Addendum No. 1

Project: Extend Taxiway G and Construct Taxilane K1
FWACAA Project No. AF26-04

Date: June 23, 2026

U1.0.1

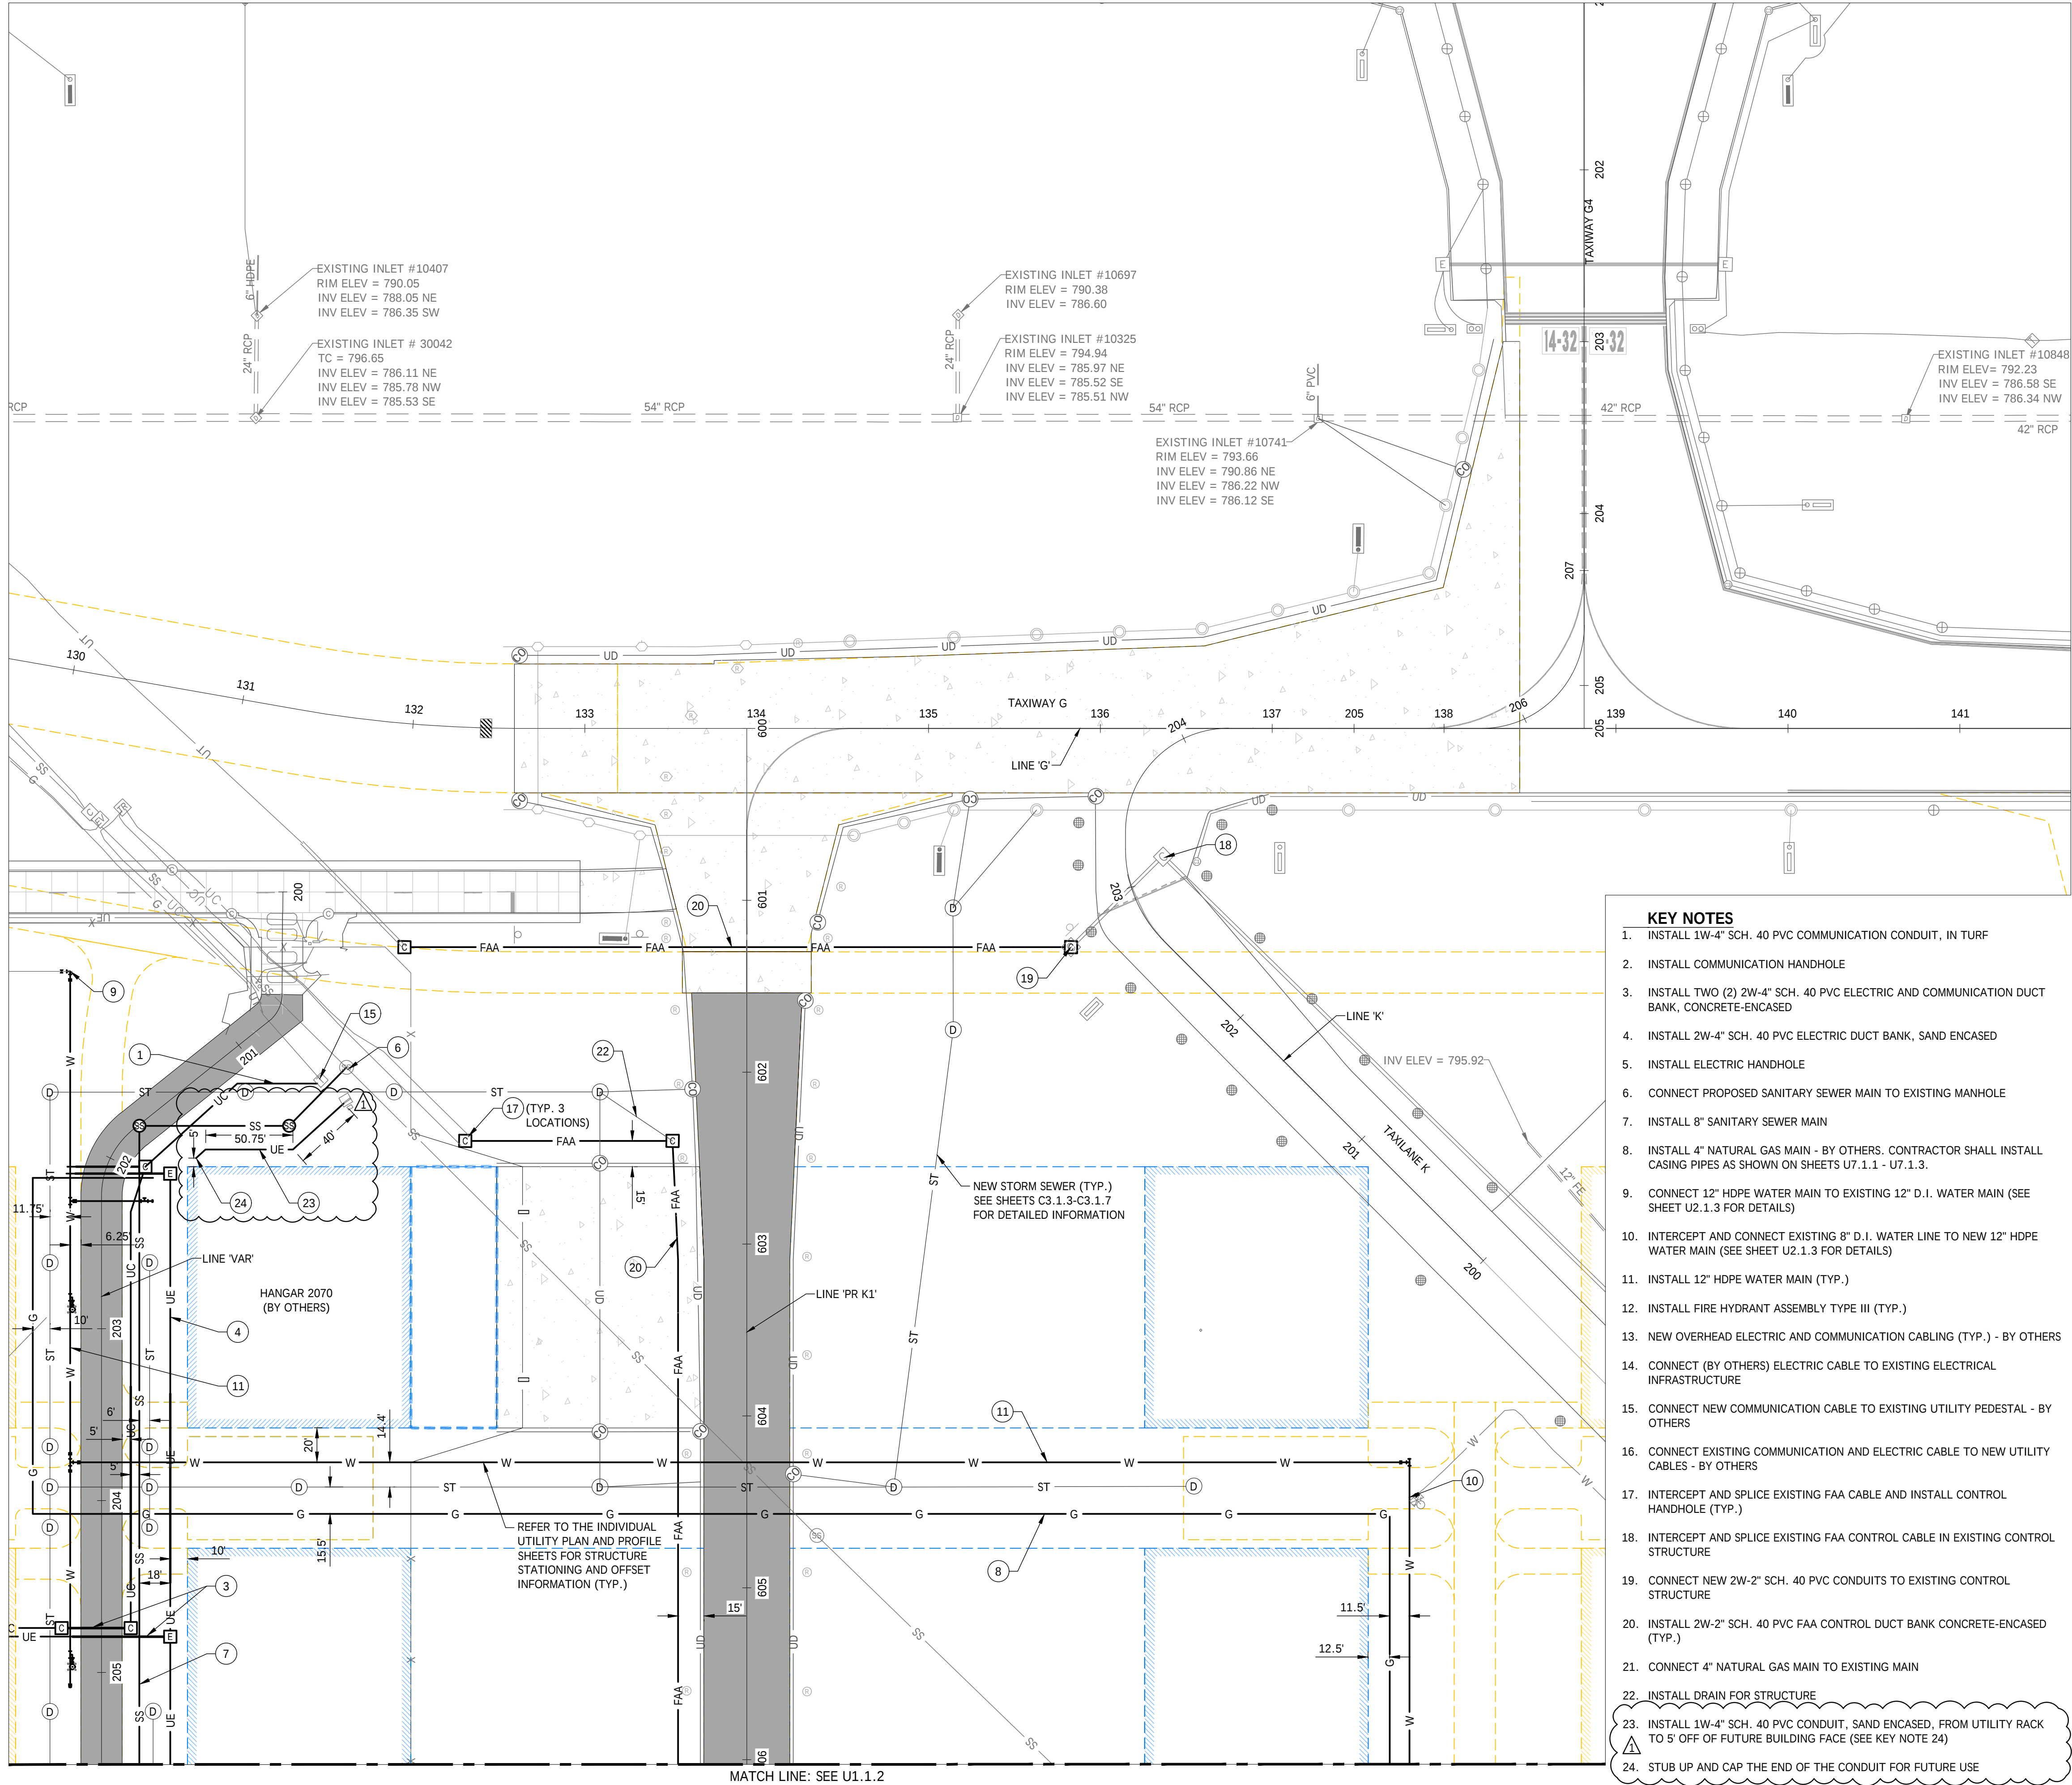
Sheet U1.0.1 – Overall Utility Plan

Reissued: Due to various changes this sheet has been reissued, and revisions are denoted with revision clouds.

U1.1.1

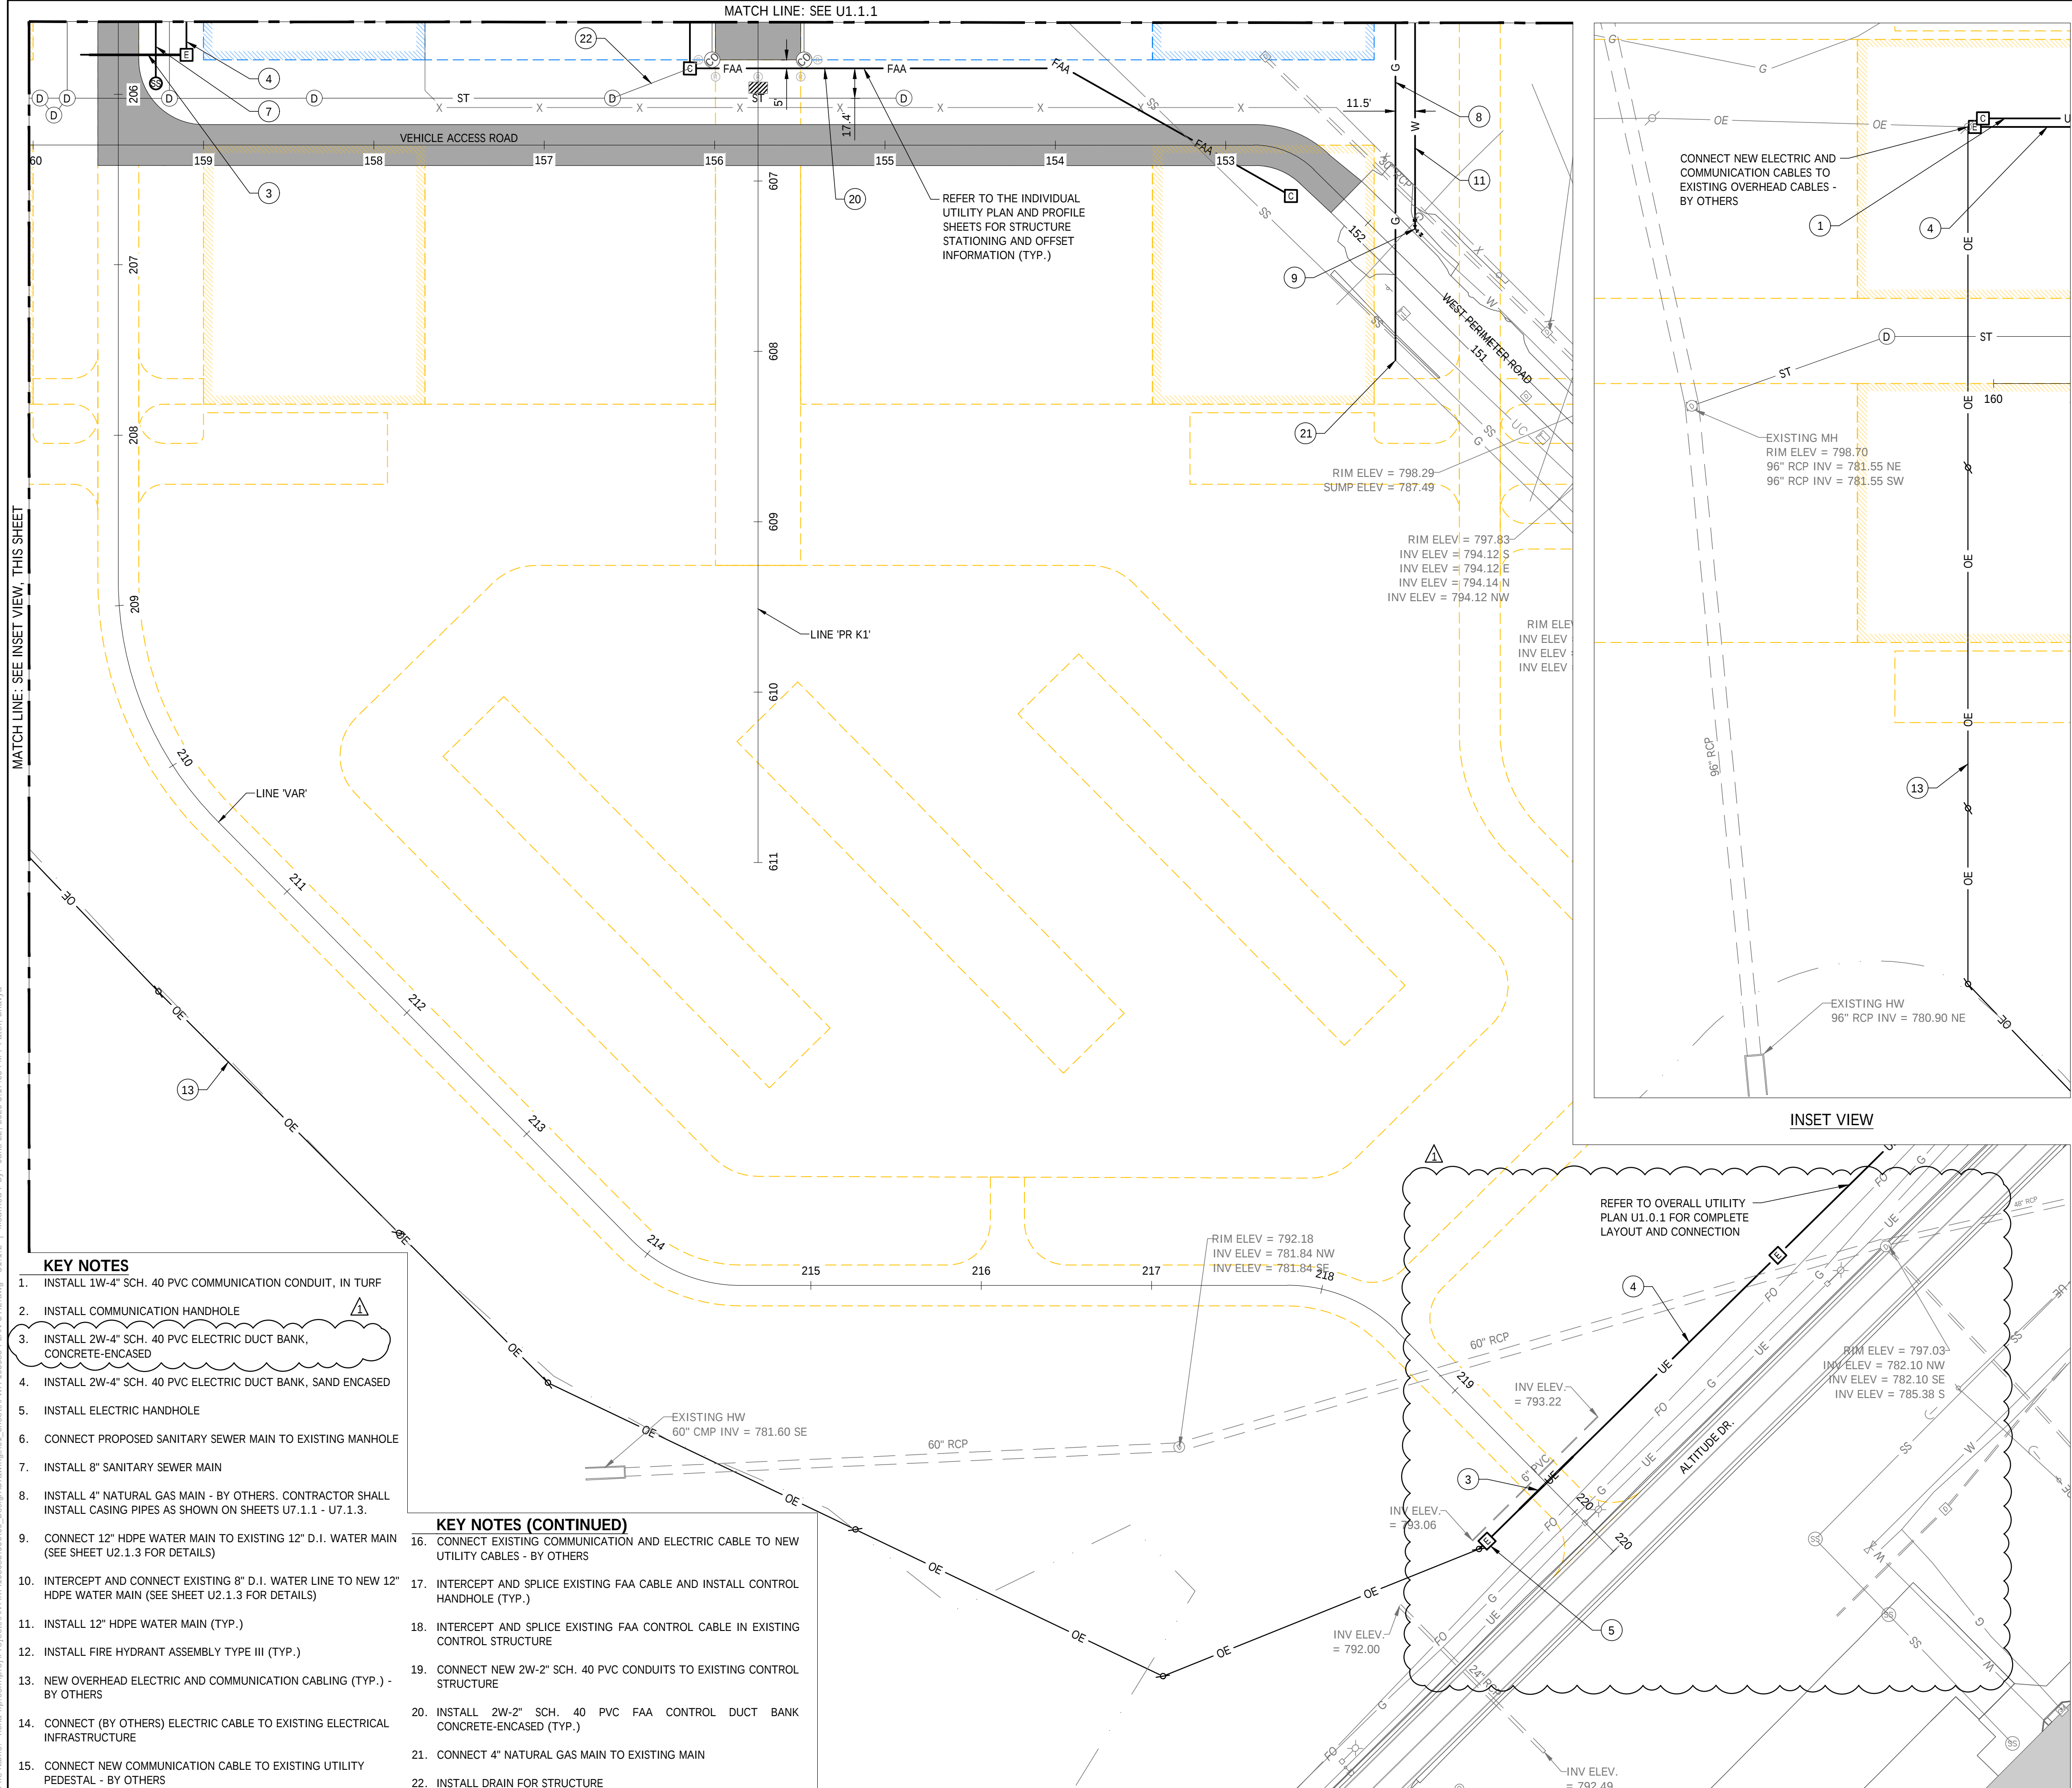
Sheet U1.1.1 – Utility Plan -1

Reissued: Due to various changes this sheet has been reissued, and revisions are denoted with revision clouds.
